PLANT NAMES: Kewaunee Plant

Subject; Request for Additional Information
Your Letter of October 4, 1972

CONTAINMENT PRESSURE RESPONSE TO LOCA

COMPARTMENT DIFFERENTIAL PRESSURE ANALYSIS

Figure -9

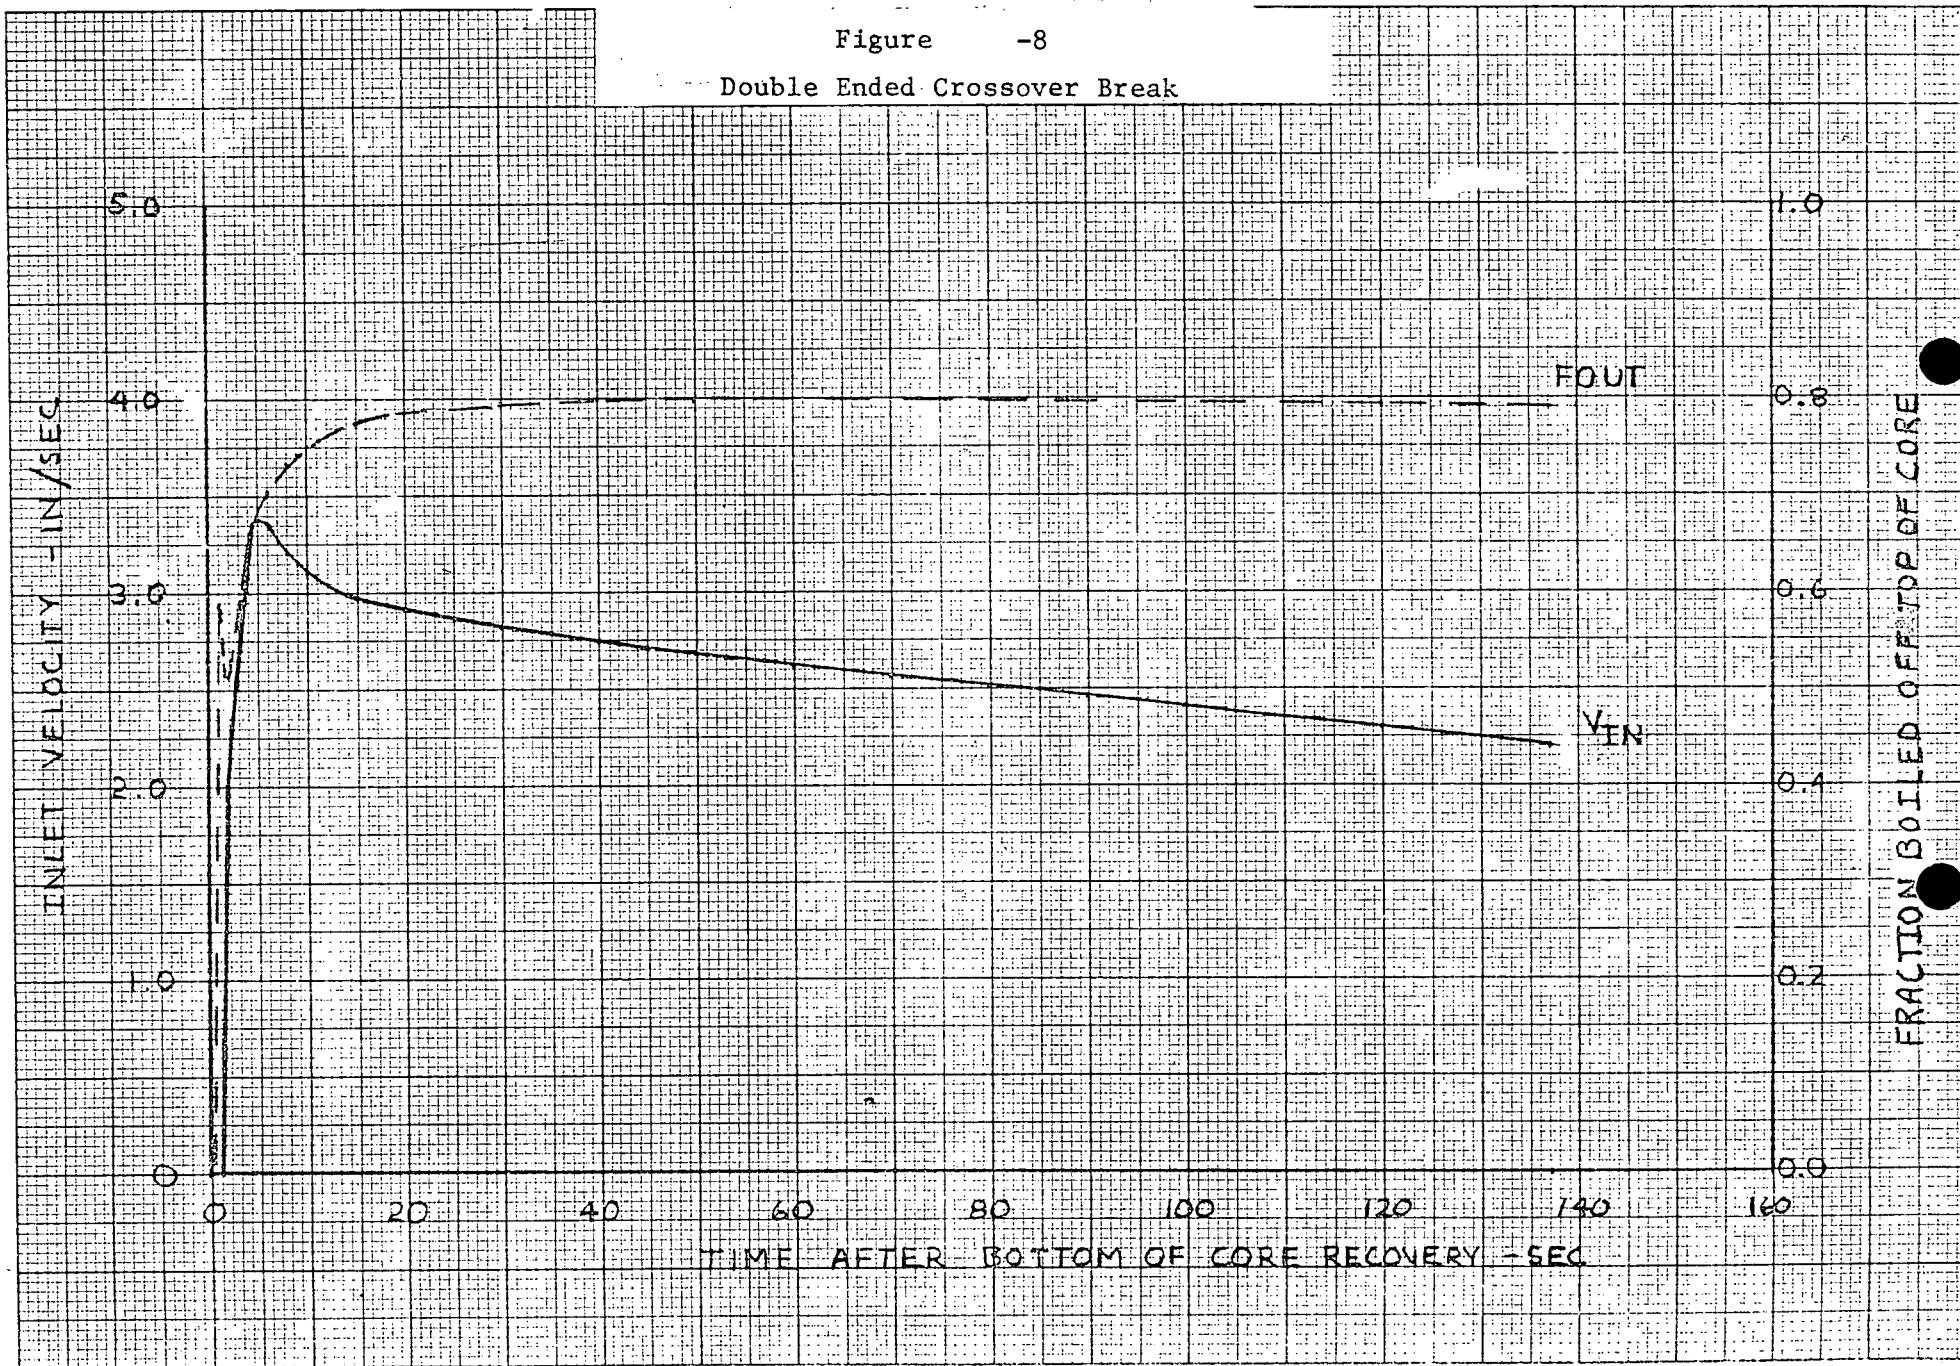
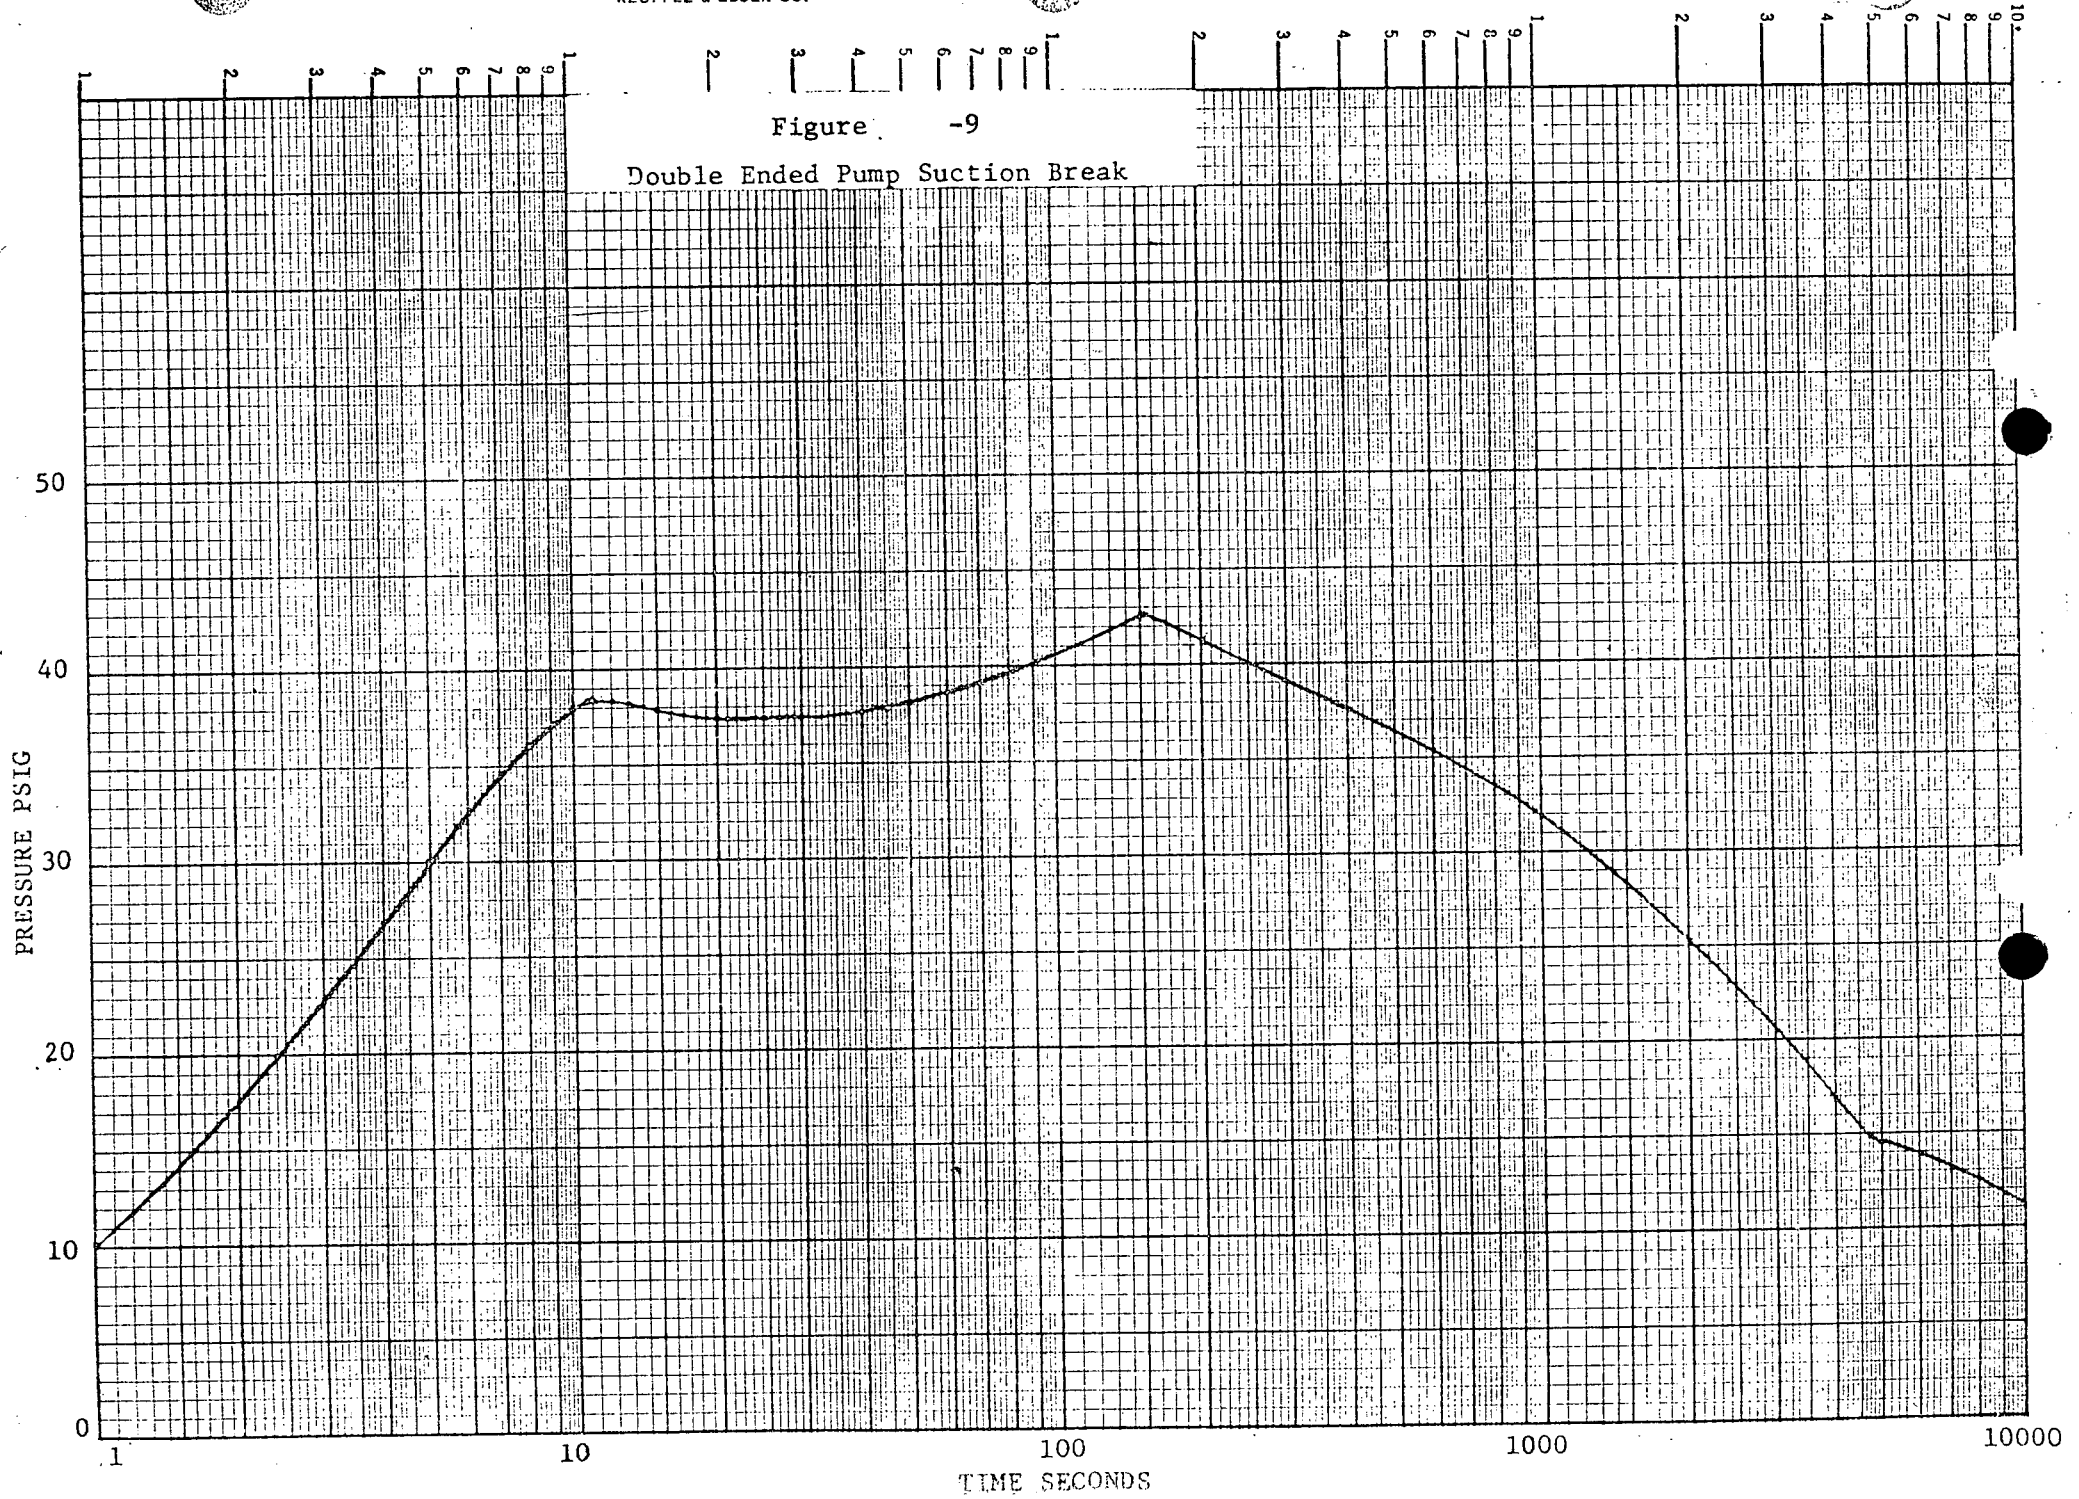
Containment pressure-time response analyses should be provided for selected design basis loss-of-coolant accidents. Double-ended breaks of the largest reactor outlet pipe and double-ended breaks of the reactor coolant pump suction and discharge pipes should be included. Smaller pipe breaks should also be analyzed and should be selected to be representative of the spectrum of break sizes for both inlet and outlet reactor coolant pipes. The analyses should be extended, as a minimum, through the blowdown, reflood and post-reflood phases of the accidents (i.e., for about 1. hour following the accident).

The analysis described above has been performed. The mass and energy released to the containment as a function of time is given in Figures 5, 6 and 7. This results in the containment pressure transient given in Figure 9. For this case the core inlet velocity as a function of time after bottom of core recovery is given in Figure 8. The peak pressure for the design case is 42.7 psig.

Figure 1 Schematic of Volumes and Flow Areas for pipe rupture in steam generator vault.

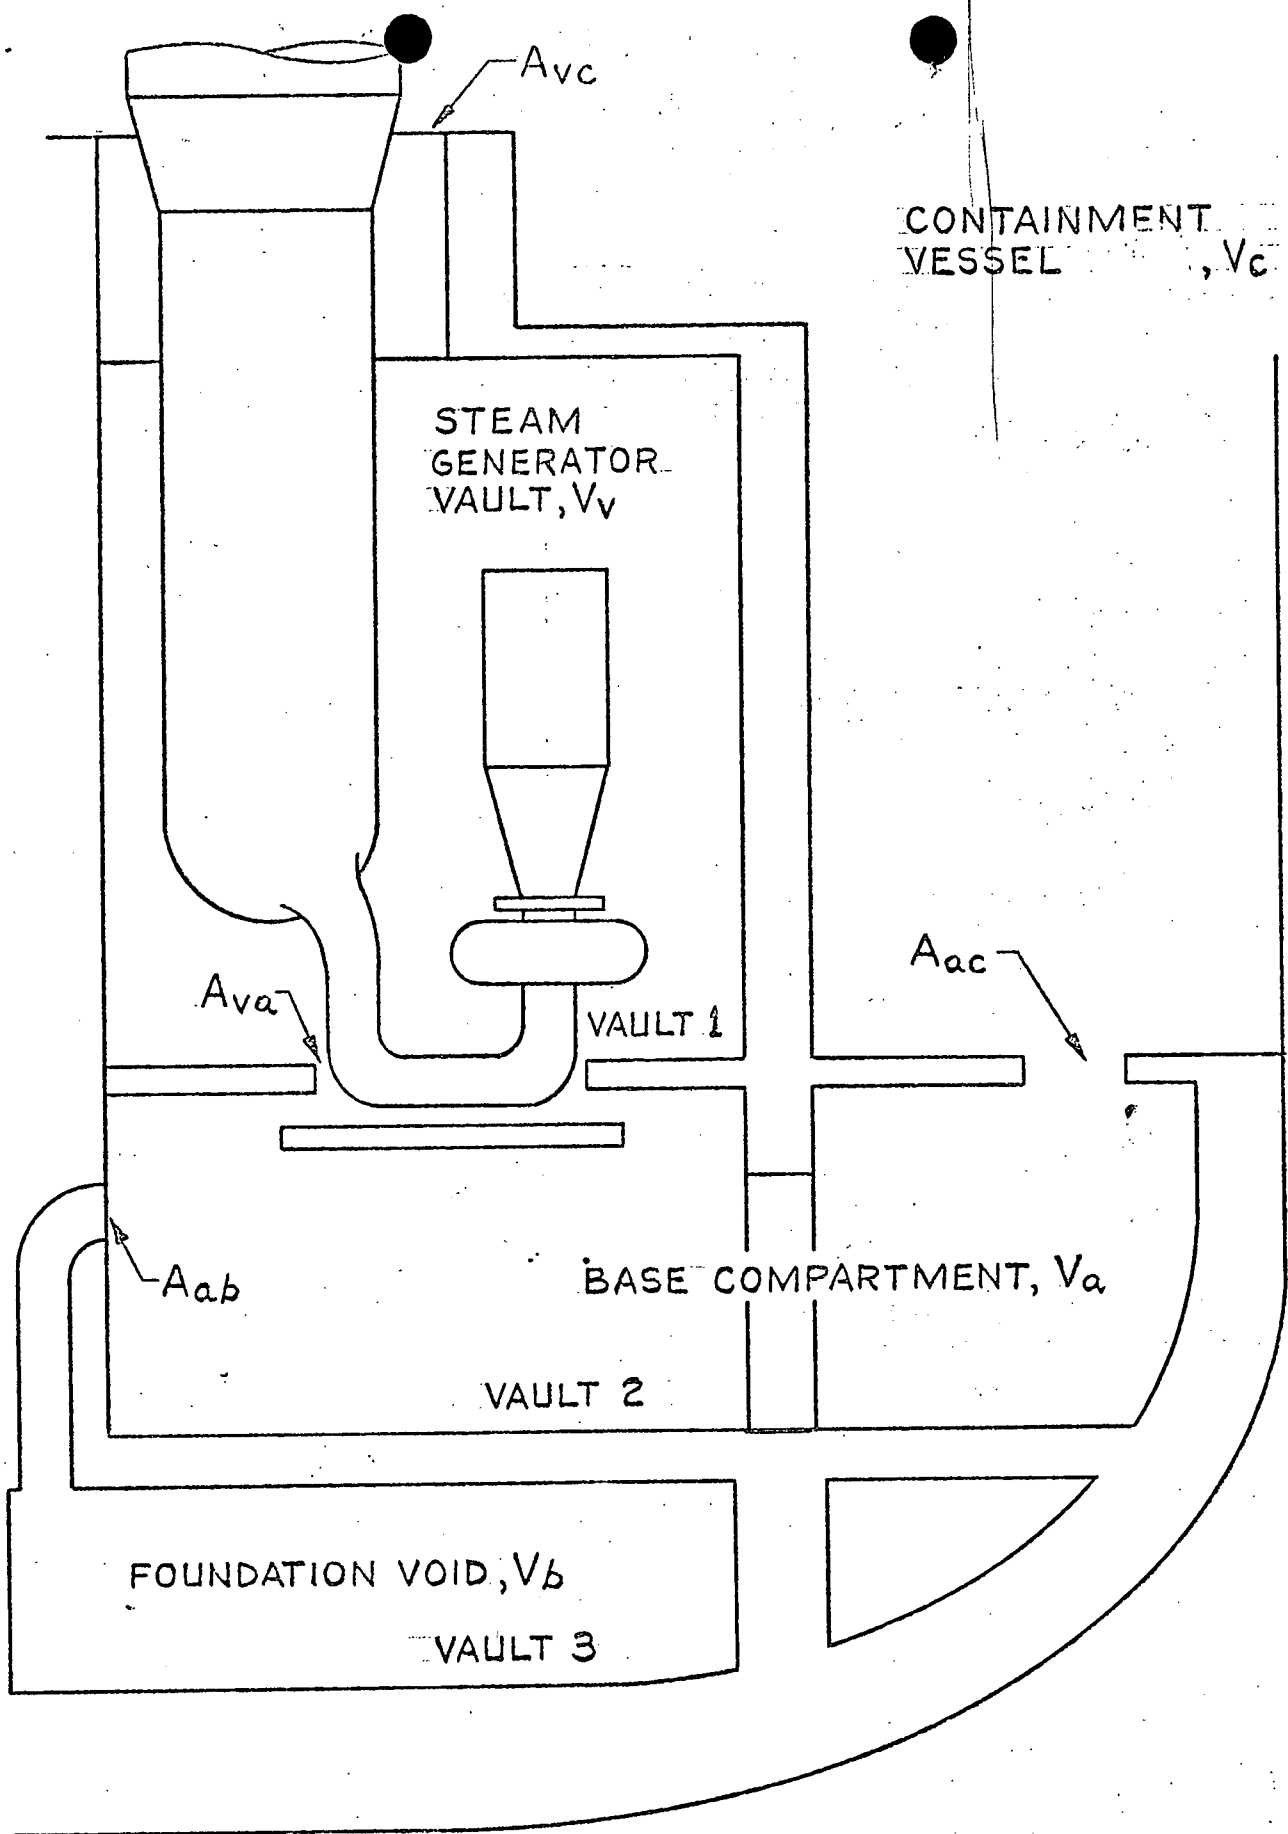
Identify the reactor building compartments analyzed. Provide the reactor coolant system break size and the free volume and vent area for each compartment.

The reactor building compartments considered in the differential pressure analysis are the steam generator vaults, the base compartments, foundation void, penetration annuli, reactor vessel gap and the tube tunnel. Sketches of compartment locations are shown in Figure 1 and Figure 2, and the associated volumes and opening areas are given in Tables 1 and Table 2.

The analysis of the steam generator vaults and connecting compartments (see Figure 1.) used a 3ft.² pump suction break. Analysis of the nozzle annuli and reactor vessel gap (see Figure 2.) used the initial mass and energy flow rate values of the 3 ft.² pump suction break because the initial flow rates were the maximum values.

Figure 3. Mass and Energy Blowdown Rates

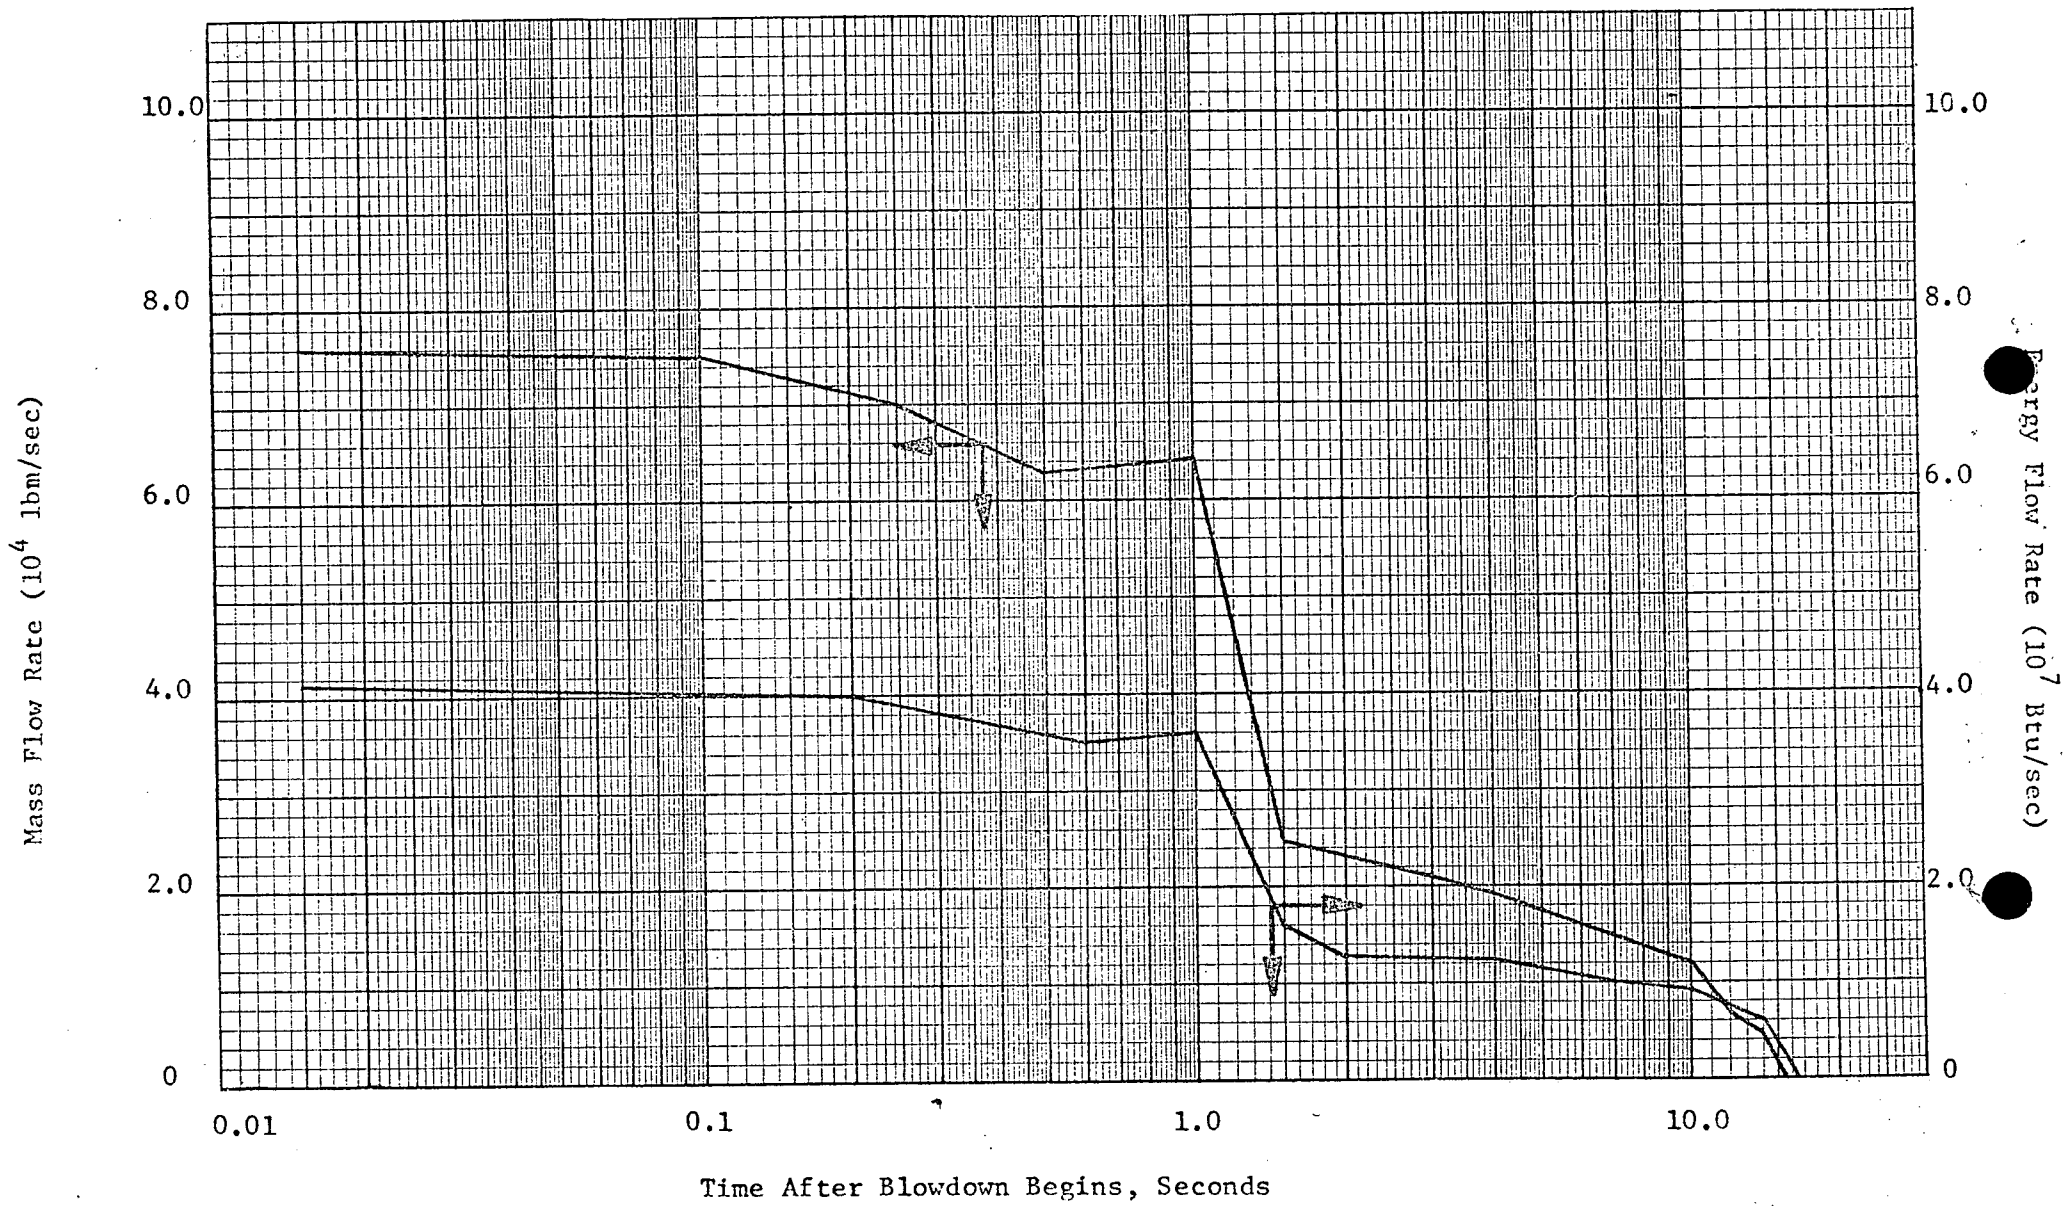
Describe the analytical model used to perform the analyses and discuss the assumptions in the model, including moisture carryover and the time steps used in predicting pressure differentials across compartment walls.

In the compartment pressure computer code the vault where pipe rupture occurs has mass and energy input flowrates based on the flowrates from the reactor system blowdown code. (Figure 3.) The initial conditions of each vault are identical to those of the bulk containment; namely 120°F and 14.7 psia. A sequence of calculations are performed to determine the mass and energy transferred between compartments for a short time interval (10 msec) and to compute the resulting compartment pressures. The time interval was carefully selected to assure the solution for compartment pressure transients converged. The sequence begins by evaluating the mass and energy input rates to the rupture vault at the midpoint of a time interval and adding these increments to the current amounts in the rupture vault. An intermediate state is then obtained by applying energy and mass balance equations to the total contents of the rupture vault. No discharge or outflow is assumed to take place at this intermediate phase of the calculation.
